Delegated Decisions by Cabinet Member for Environment (including Transport)

***Thursday, 25 February 2021 at 10.00 am
Virtual***

4. Oxford - Ferry Hinksey Road and Osney Mead: Proposed Shared Use Footway/Cycletrack, Parallel Crossing for Cyclists and Pedestrians and Amendments to Parking Places (Pages 1 - 14)

Report by Interim Corporate Director Communities (**CMDE4**).

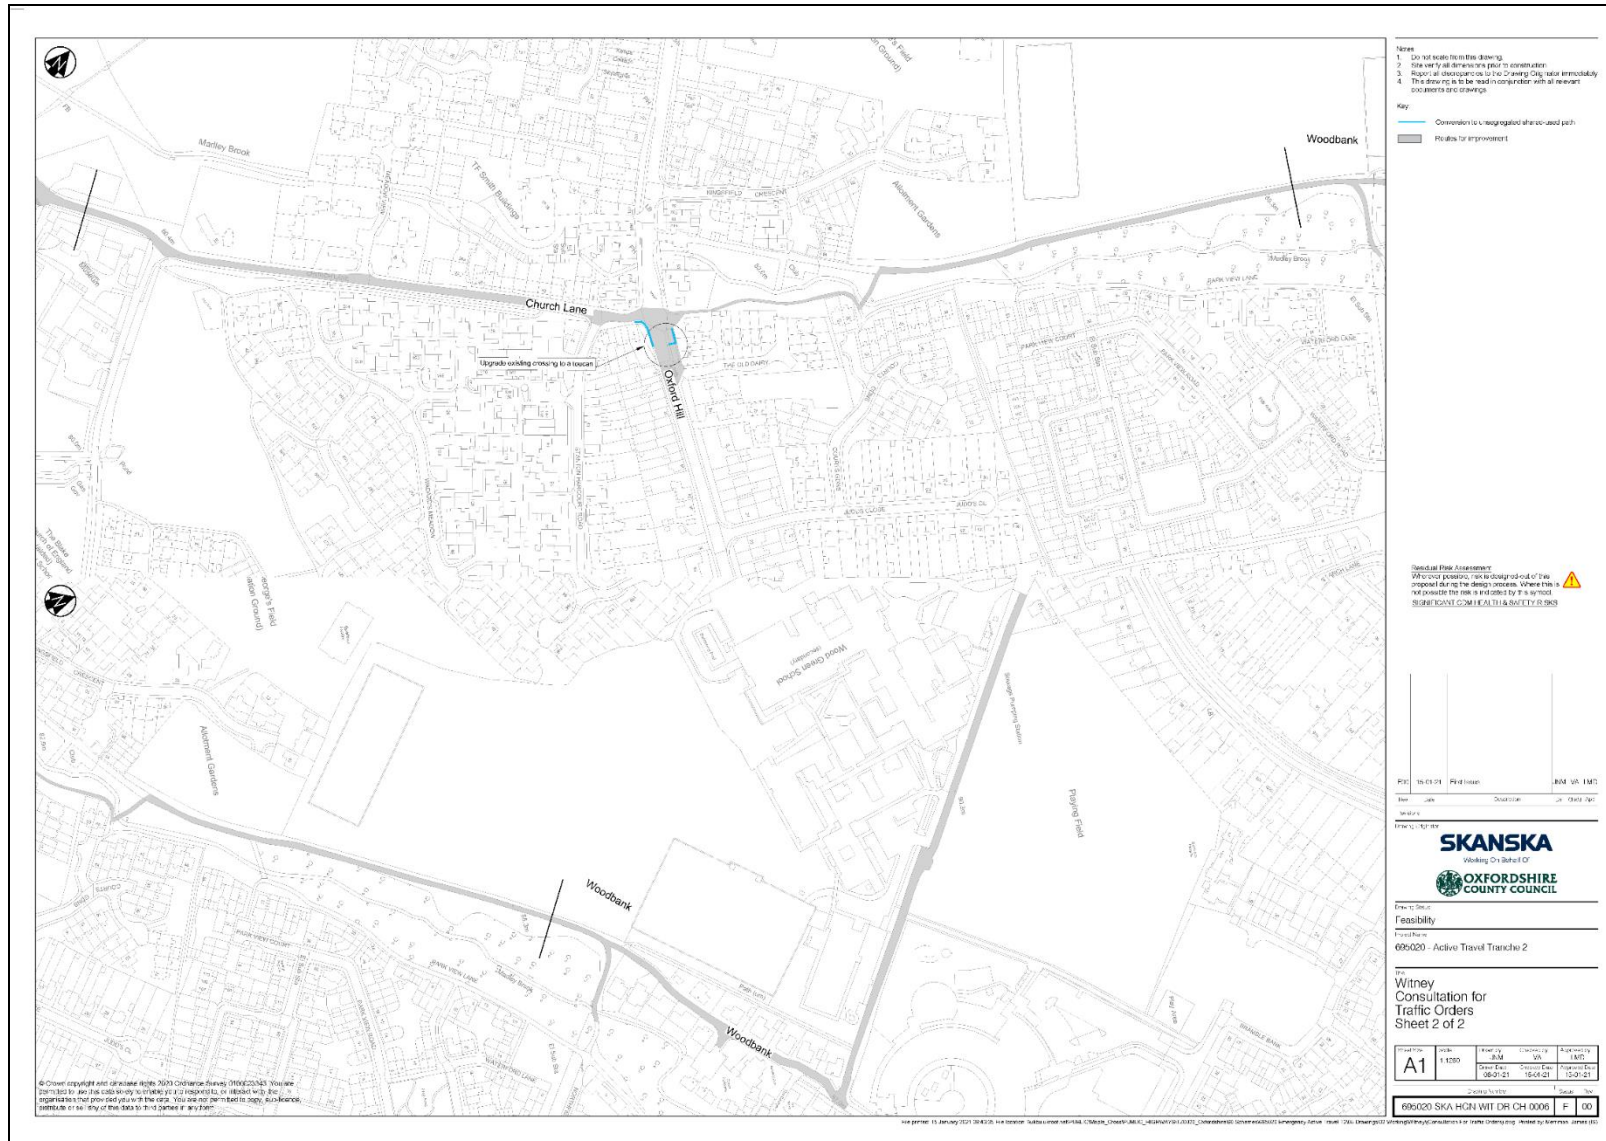
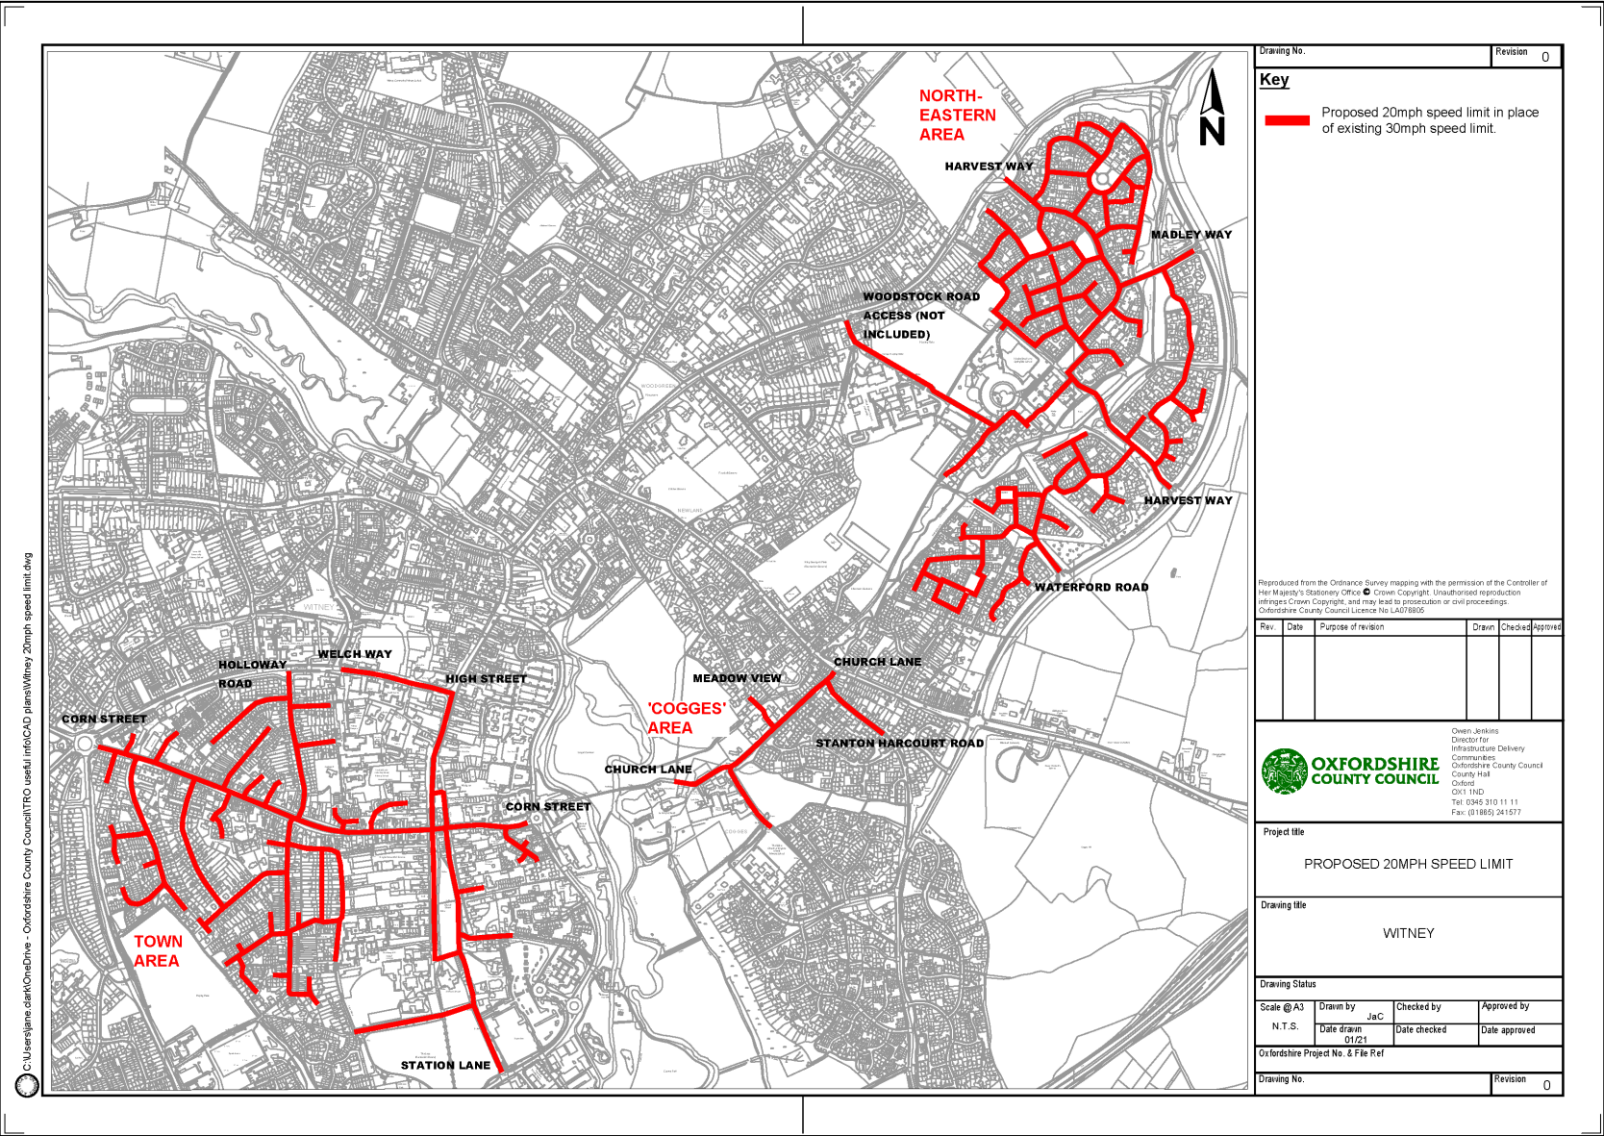
27. Eight responses, including Oxfordshire Association for the Blind, have objected to the proposals to convert areas of footway to shared-use cycle paths. Concerns include the potential for conflict occurring between those walking and cycling, due to the lack of space. Ideally all the proposals would provide dedicated space for cycling, however due to the constrained footway and carriageway widths it is not possible to deliver segregated paths which meet the national design standards. However, where possible the shared use paths will be a minimum 3m (the recommended width for shared use in LTN 1/20 table 6-3); there will be small sections where due to physical constraints this will not be possible, but these will be limited.

31. A couple of respondents objected to the proposals for toucan crossings and concerns were raised about the impact on pedestrians. Toucan facilities will provide crossings that meet the needs of both those walking and cycling. Upgrading existing signalised pedestrian crossings to toucan crossings will allow mounted cyclists to cross the road. We will be using infrastructure to aid

(8) Resident, (Eynsham)	<p>20mph Speed Limit - Object Toucan Crossings - Concerns Shared-use Cycle Paths - Object Experimental Parking Removal - Concerns</p> <p>20mph not easy to enforce Crossings need lights, for safety of pedestrians and drivers Mixed use paths very dangerous. People need to know what to expect, and what is expected of them</p> <p>There is a current craze for more walking and cycling, as if it's a panacea towards climate change. During the pandemic we have seen all cycle shops sell their entire stock, and have nothing to replace it with for months, as like most things we used to make we now import virtually all cycles. Now that new stock has arrived, the shops are awash with second hand bikes, that are selling for a fraction of their recently bought new price.</p> <p>If we are going to take cycling seriously in the UK, we need to commit to building proper cycle tracks, not putting a few dotted lines on the pavement, or road. This will mean in most cases having to widen roadways, and that will mean having to demolish houses, shops etc on at least one side of the road! If you are not prepared to do this then forget it, as in most circumstances you will either inconvenience or endanger pedestrians or motorists, remember roads are for motor vehicles, and pavements are for pedestrians.</p> <p>As a cyclist, motorcyclist and driver, who has covered over two million miles in a number of countries, no other country tries to do things on the cheap like the UK. Either do the job properly or not at all. Every day I see the traffic stationery on the a40 between Oxford to almost to the second Witney turn on the bypass, yet there are never any more than half a dozen cyclists on the purpose built cycle paths, when you would think they would be crowded.</p> <p>The other problems involve the lack of proper maintenance of the average cycle and the lack of training of the cyclists. Most cyclists take no notice of road signs, and are prepared to put their lives in danger, by relying on motorists raking avoiding action, when they place themselves in danger.</p> <p>If cycling is going to be taken seriously then both cycle and cyclist, must be maintained and trained, therefore all cycles must be registered, tested taxed and insured as both are lethal in the wrong hands</p>

(26) Local Resident, (Witney)	<p>20mph Speed Limit - Support Toucan Crossings - Support Shared-use Cycle Paths - Concerns Experimental Parking Removal - Concerns</p> <p>Shared Use cycle paths can be quite dangerous when people meander about, and fail to control their children, or their dogs. Will there be a line down the middle, to separate the two uses and, if so, will this be well signed? (Not that many people will take much notice anyway, if behaviour on Langel Common is anything to go by!)</p> <p>Cycle paths are needed on Hailey Road, but nothing seems to be planned, and some lighting (solar?) across the meadow between Hailey Road and Mill Street.</p>

people with disabilities throughout the design, such as tactile paving, and cones/ bleepers at the toucan crossings. The scheme seeks to increase the number of people walking and cycling and provide infrastructure to make it more convenient and safer to walk and cycle. The proposal to convert crossings to toucan crossings meets these aims.

Proposed Cross Section "A-A" of Carriageway & Footway

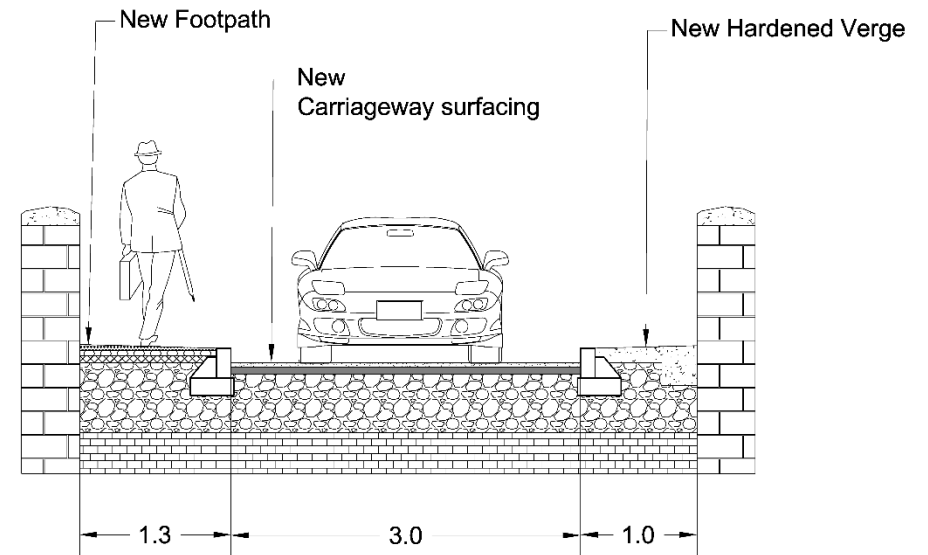
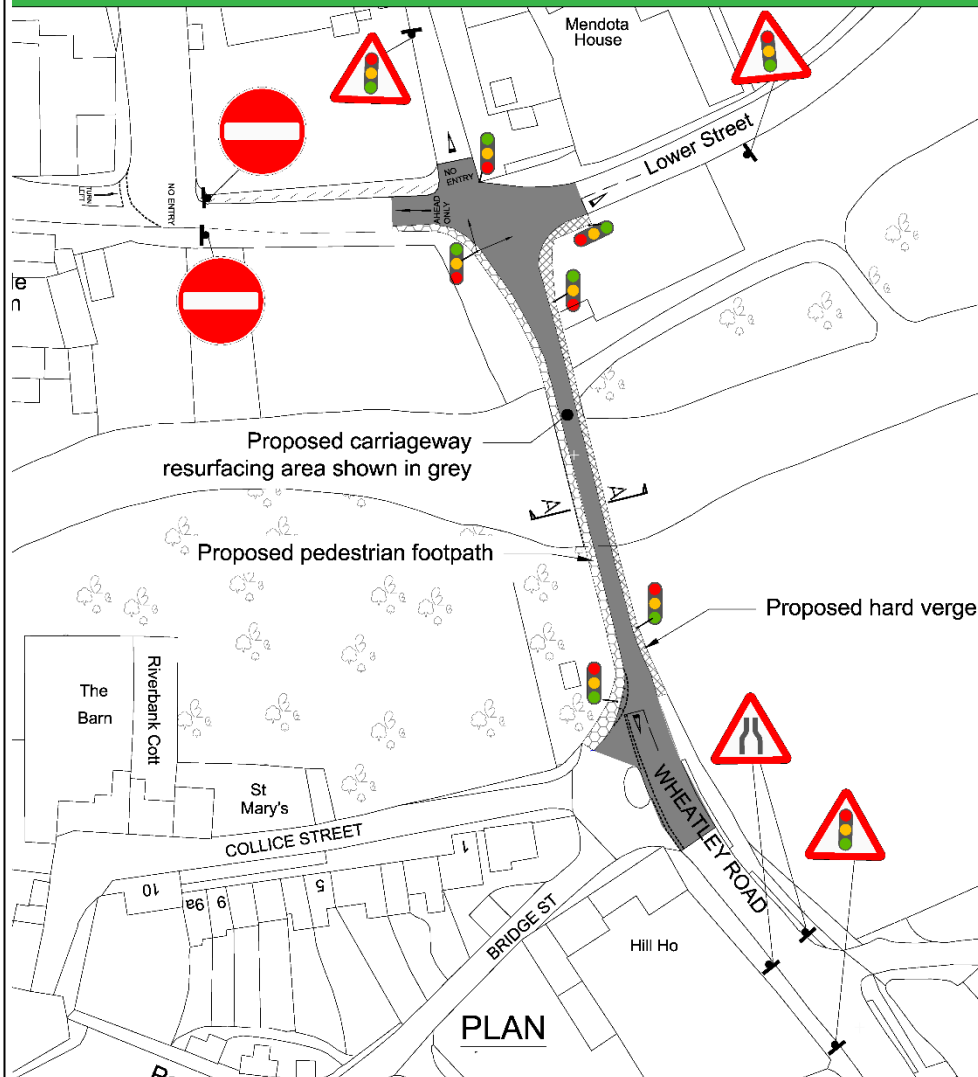
Asked why the traffic signal head on the north side of the bridge cannot be moved closer to the bridge as was previously positioned when temporary traffic signals were provided. A swept path analysis of vehicle turning movements has been carried out. Without moving the traffic signals further back longer vehicles heading north and turning left into Mill Street will clash with queuing traffic heading south. It is considered impractical to widen the highway over this section of the road to avoid this, i.e. land would need to be purchased and major modifications made to the retaining walls to the river.

(6) Local Resident, (Islip)	<p>Object - I wish to register a strong objection to the proposed installation of traffic lights on the B4027 at Islip bridge.</p> <p>I live at the top of King's Head Lane in the High St. just before the road becomes One-Way. When temporary traffic lights have been previously installed, vehicular access to and from my property was impossible; blocked by queuing traffic. Every day from dawn, traffic would tailback beyond the Village boundaries.</p> <p>The proposed plans would replicate and exacerbate these circumstances and stationary traffic will cause serious pollution - way beyond acceptable levels.</p> <p>Your notice indicates a need for an altered One-Way system. We already have a One-Way system in the Village which adequately copes with the through traffic; if however it is the integrity of the bridge which is at issue, the Council and Highways Agency are collectively negligent in not considering less impacting remedies and public consultation on such a sensitive matter.</p> <p>Heavy duty commercial vehicles contribute far more damage to the bridge than cars. We all know signage and other warnings do not deter the many big lorries looking for a short cut through Islip; so positive and physical deterrents have to be installed to bar their route.</p>

(61) Local Resident, (Islip)	<p>Concerns - I should say that I understand that the planned traffic light system is primarily driven by pressing concerns about the structural strength of the bridge and the desire to restrict vehicular traffic to the middle section of it.</p>

carriageway. There should also ideally be footway provision across this bridge for which the absolute minimum width should be 1.0m. As part of the bridge load mitigation measures the narrowing is proposed to be slightly offset to provide a useable footway, with an upstand to deter overrunning, although overrunning should be far less of a problem once traffic signal control is in place. It is considered at this time that the proposals will serve as a reasonable medium-term solution to address the problems with the bridge. There are numerous other higher priority bridge works for which there is currently a funding and resource shortfall, such that it is anticipated that a multi-million pound expenditure on Islip bridge is not now warranted.

A conservation style rather than standard precast concrete kerb can be provided, but these still need to be able to provide their primary engineering function, i.e. highway drainage and to deter vehicles from mounting them, but still be over runnable by the occasional large wide agricultural vehicle, i.e. combine harvester (see 5 below).

Widening of the bridge has been considered not to be viable, such that in order to provide adequate width for two-way traffic flow the bridge would need to be replaced.
